REGULAR CALENDAR
STAFF REPORT AND PRELIMINARY RECOMMENDATION

Application No.: 6-97-45

Applicant: SDG&E

Description: Dredge between 155,000 and 200,000 cubic yards of lagoon bottom (sand) within the outer basin of Agua Hedionda Lagoon starting September 15, 1997 and ending April 15, 1998. The sand is proposed to be placed on the "South Beach", in a 1,100 foot long and 200 foot wide area directly south of the Encina Power Plant discharge jetty on Carlsbad State Beach. The applicant is also requesting approval to dredge up to 500,000 cubic yards in any single event (dredge cycle) for a five year maximum (to 2002) total dredging volume of 1,250,000 cubic yards.

EXHIBIT NO. 2
APPLICATION NO. 6-97-45
limits of Deposition
California Coastal Commission

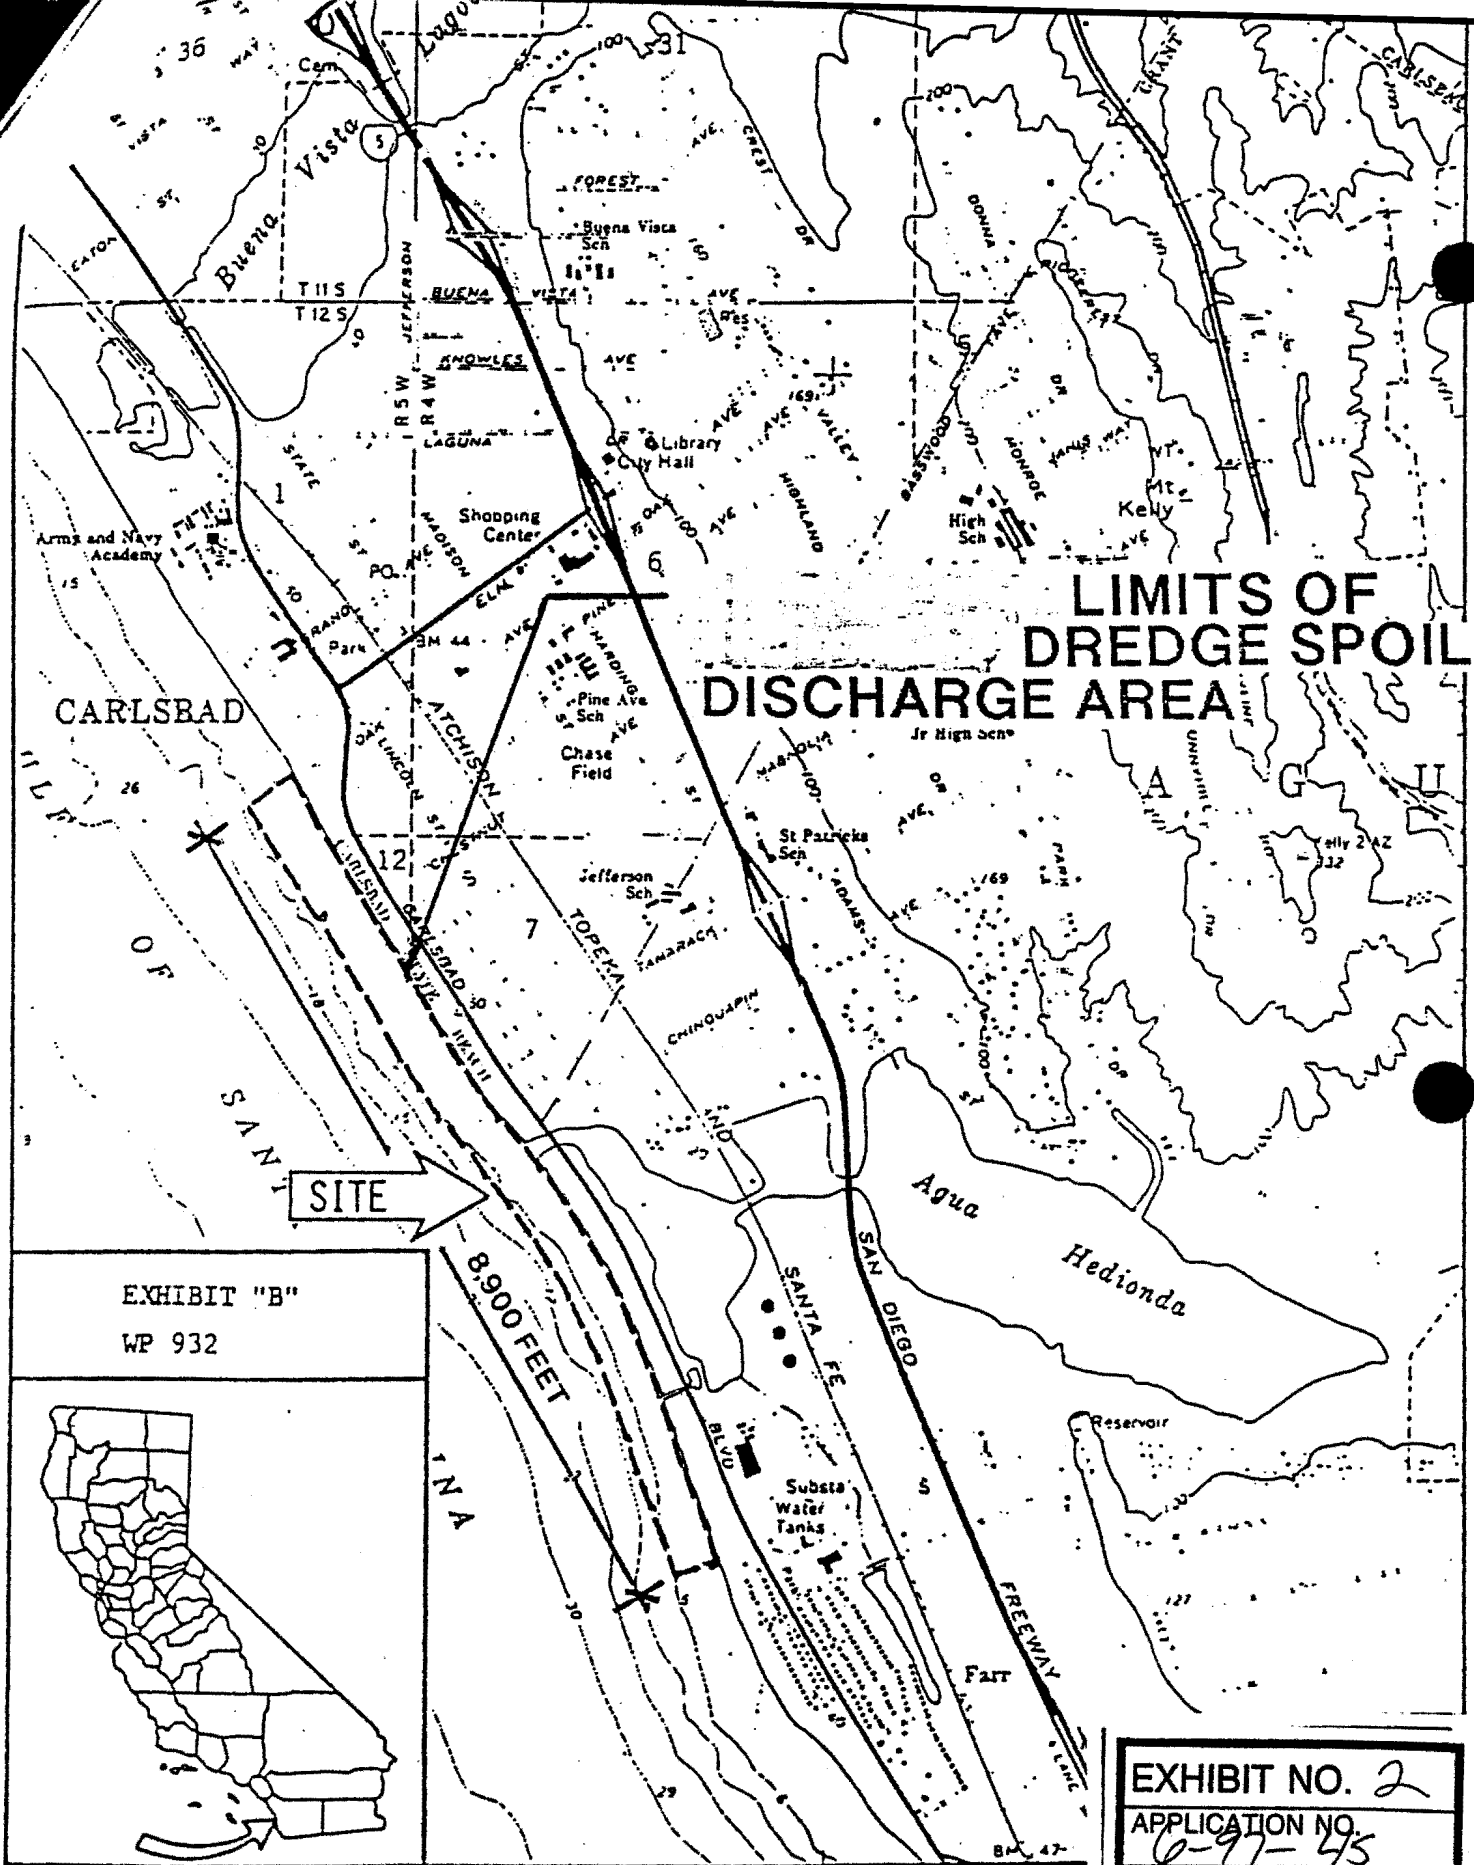
Staff is recommending partial approval of the applicant's request with conditions which allow a one-time dredge of up to 200,000 cu.yds. of material to be placed on the Middle Beach rather than the South Beach as proposed by the applicant. Staff's preferred deposition location will provide a greater recreational benefit to beach users along the Carlsbad shoreline because the Middle Beach is the most heavily attended beach in Carlsbad and has supporting parking facilities, public walkways and lifeguard service, while the South beach provides less beach use and support facilities. Staff is also recommending the applicant do a monitoring study of sand transport along the Carlsbad shoreline to determine where the best beach nourishment sites are at any given time for deposition of dredged material resulting from SDG&E's maintenance dredging of Agua Hedionda Lagoon. Absent this study, staff recommends the Commission deny the applicant's request to dredge up to 1,250,000 cu.yds. of material within the next five years. Further, staff recommends that any subsequent dredge cycles be subject to a separate coastal development permit and involve coordination with the Corps of Engineers, City of Carlsbad and State Parks to determine the appropriate disposal site(s) for the future. The attached conditions of this approval require final deposition plans, address sensitive resources, require final approval by the Corps of Engineers, and the State Department of Parks and Recreation.

Thus, based on conflicting opinions of shoreline experts and the lack of definitive studies that corroborate either the City's or the applicant's position, the Commission finds that the sand should be placed where it would provide the most recreational benefit to coastal visitors. Staff has visited the project area and notes that the area that provides the most public recreational benefit to the most users is the Middle Beach. As noted, day use parking is provided free of charge along the curb in the Middle Beach area. This area accommodates the greatest beach patronage along the Carlsbad shoreline. According to a city representative more than a million people yearly visit this beach, making it by far the most heavily-used beach in the City of Carlsbad.

Because of the above uncertainties, the Commission finds that nourishing the Middle Beach at this time would have the most positive public benefit. Should further studies and future environmental conditions dictate that sand generated from future dredgings of the middle and inner lagoons be placed at locations other than Middle Beach, other deposition locations can be approved. However, for this particular dredging it appears deposition of the sand at the Middle Beach is most consistent with the public access and recreation policies of the Coastal Act and certified Agua Hedionda LUP.

3. Term of Permit. This coastal development permit authorizes a one-time dredge of up to 200,000 cu.yds. to occur at the Middle Beach, between the ocean entrance to Aqua Hedionda Lagoon and the SDG&E discharge jetty. No extension of the permit expiration date or additional dredge cycles beyond the 1997-1998 cycle are approved.
